The failure of the National Park planning system at Cairn Gorm – the magic carpet construction

Construction of magic carpet 4th December – Photo Credit Alan Bratney

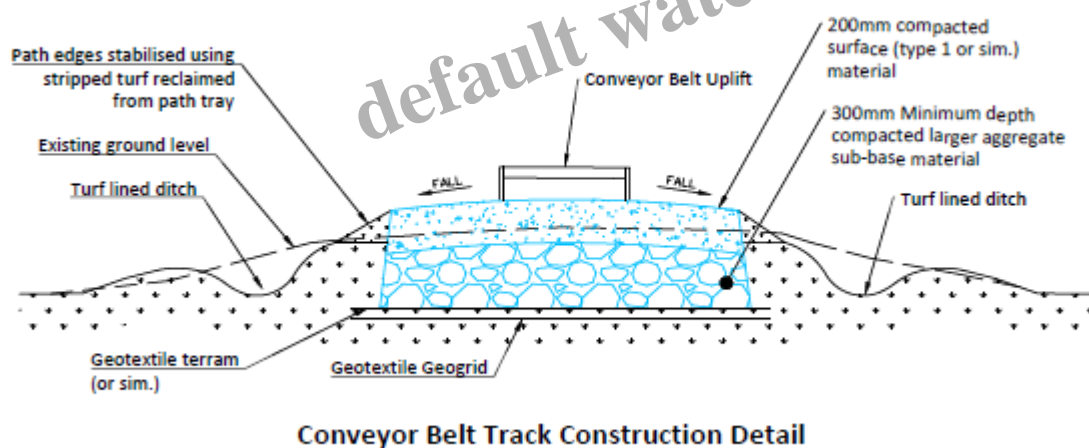
The work being undertaken to construct the lower of the two magic carpets bears no resemblance to that which was approved by the Cairngorm National Park Authority (CNPA) in May.

While it is difficult to estimate the exact width of the construction corridor from the photo, the vehicle tracks on the right suggest the corridor on the right of the conveyor is nearer four metres and more in places. It appears therefore the work McGowan is doing is not only contrary to their own Construction Method Statement, it is in breach of planning conditions.

The revised plans

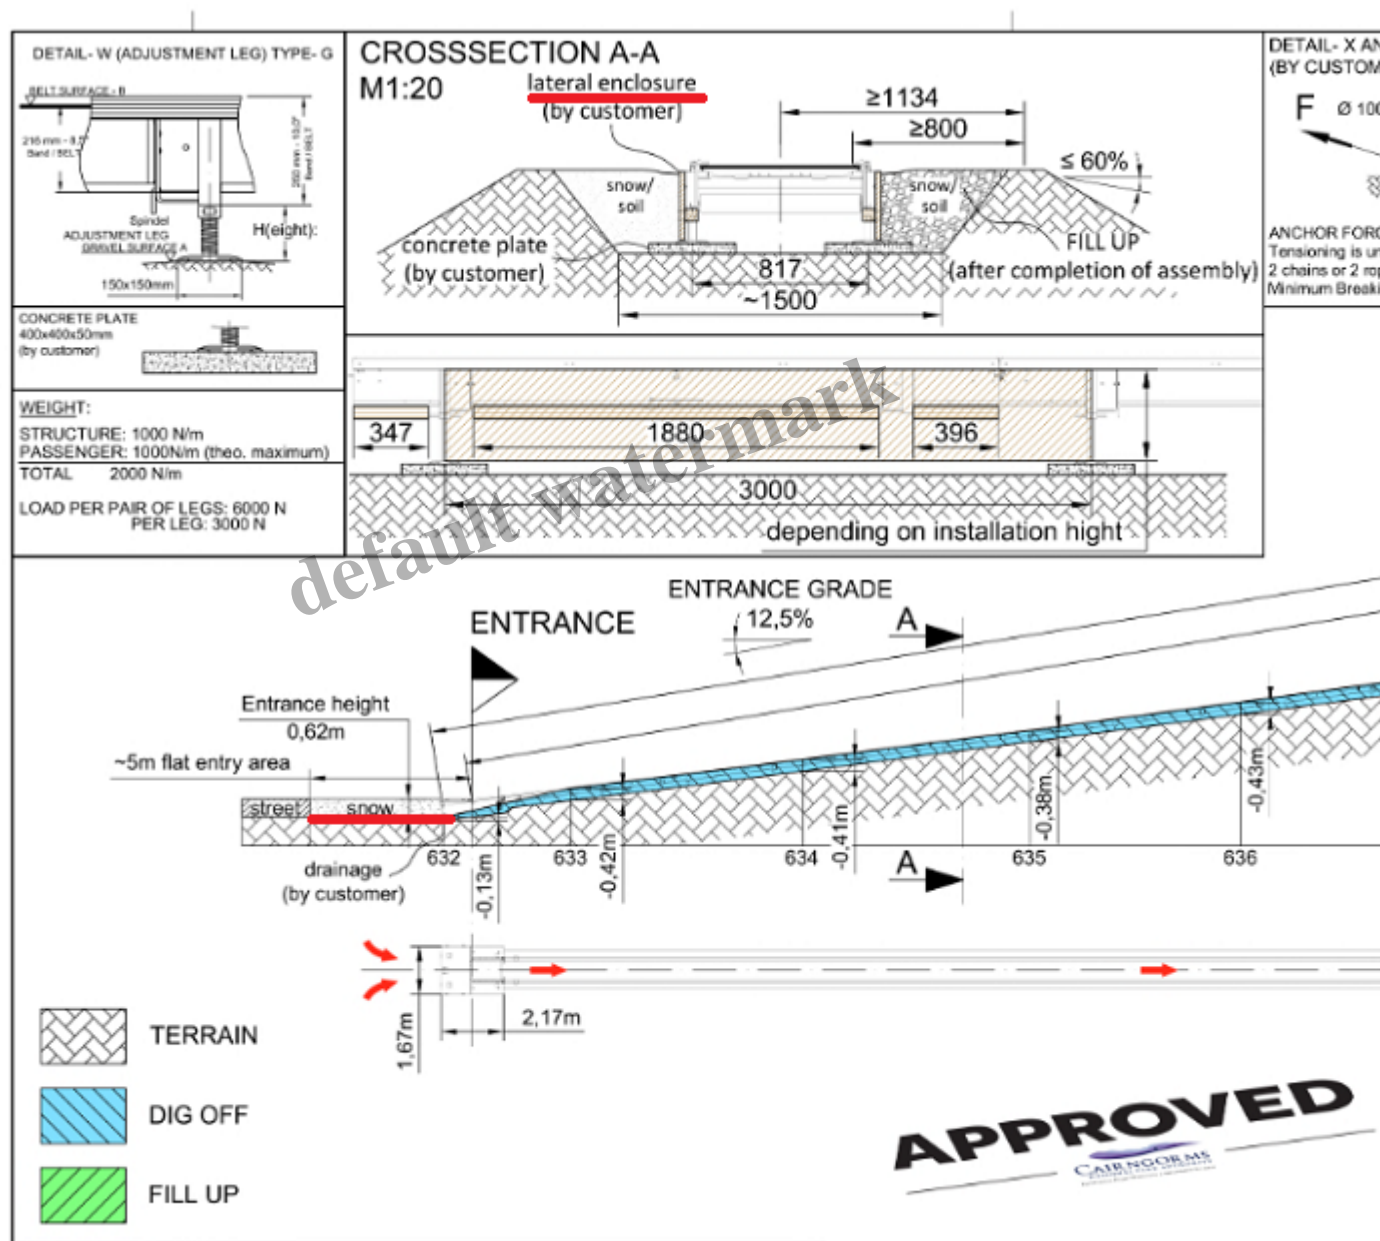
CMSL submitted plans showing the design of each magic carpet on 10th November, at least a week after construction had started. These were followed by five further documents showing the finishes on 22nd November. Unless the CNPA published these documents late, CMSL and McGowan appear to have commenced work on the magic carpet before the plans were approved.

Extract from plan for the 93m or lower belt, i.e. the one in the photo above.

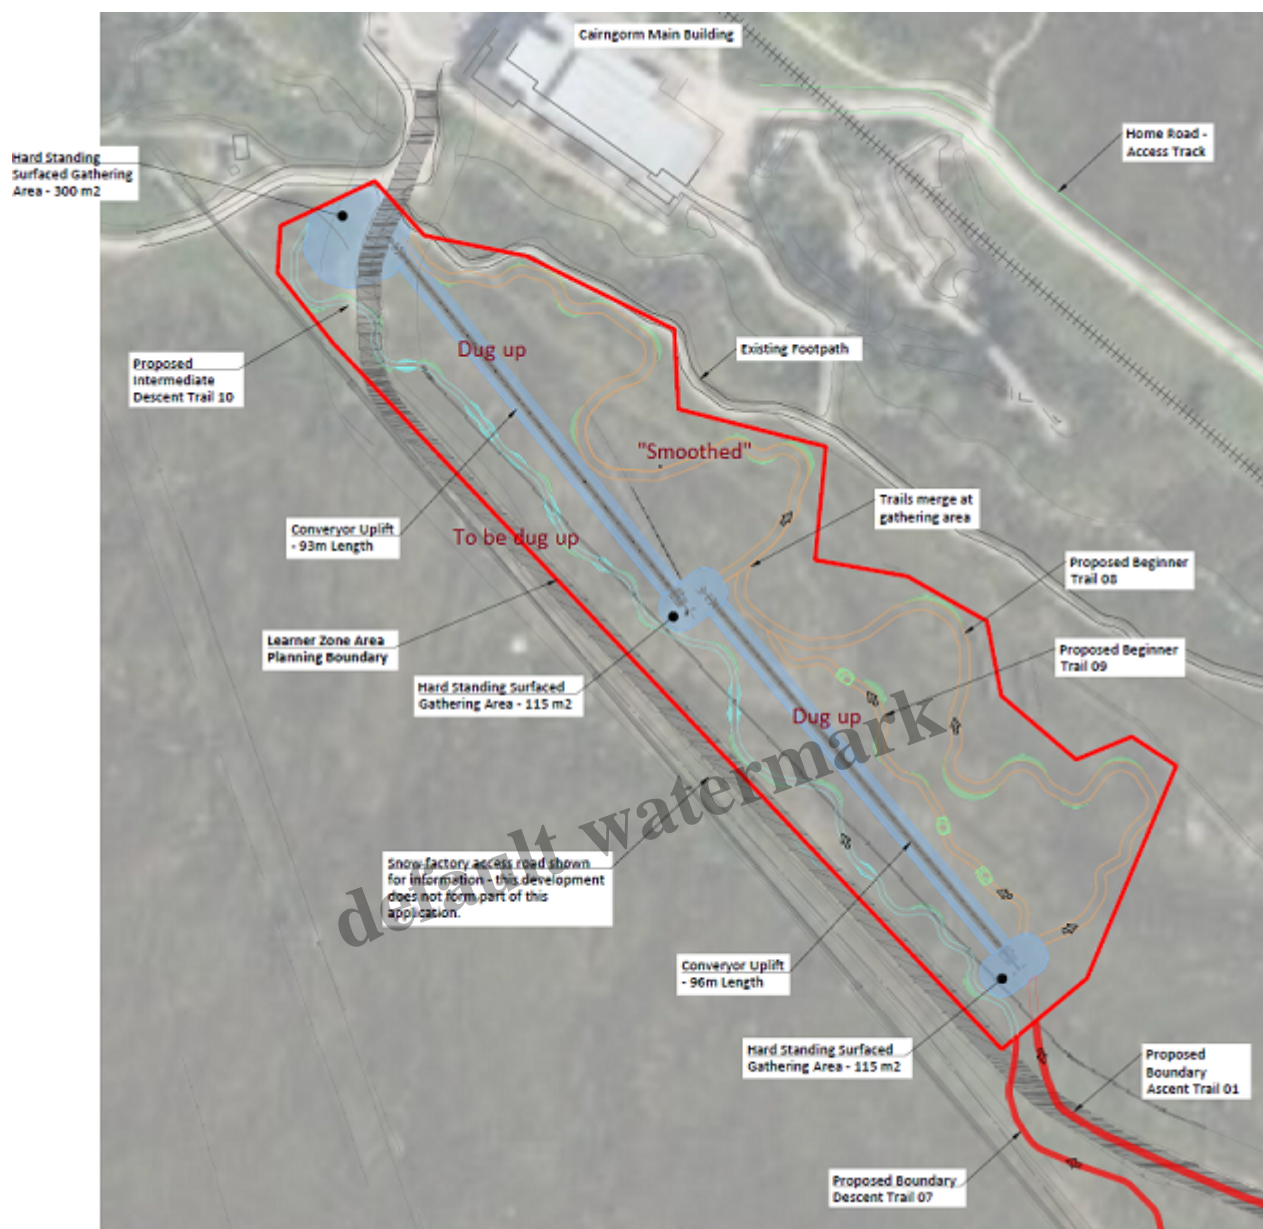
- The new plan shows the magic carpet sunk into the surrounding terrain (the hatched area). Had this been followed, only a narrow construction corridor and much smaller machinery would have been needed to install the carpet.
- In the plans the lateral enclosures of the space under the magic carpet (underlined in red) are vertical, whereas in the photo they are sloping at c45 degrees and half the space that the plans show would have been filled with soil/snow has been removed. That may not matter technically but is not in accordance with what the CNPA has now consented and means a bank will have to be constructed up the left hand side of the carpet, causing more ground disturbance.

A minor issue raised by the new plans is if terrain is to be brought up to the level of the magic carpet by packing down snow (also underlined in red), that will leave a step for children with mountain bikes to negotiate in summer on what is also supposed to be a family friendly uplift facility.

The most important point, however, is that none of the latest planning documents explain why such a broad construction corridor is required or have sought planning consent for this.
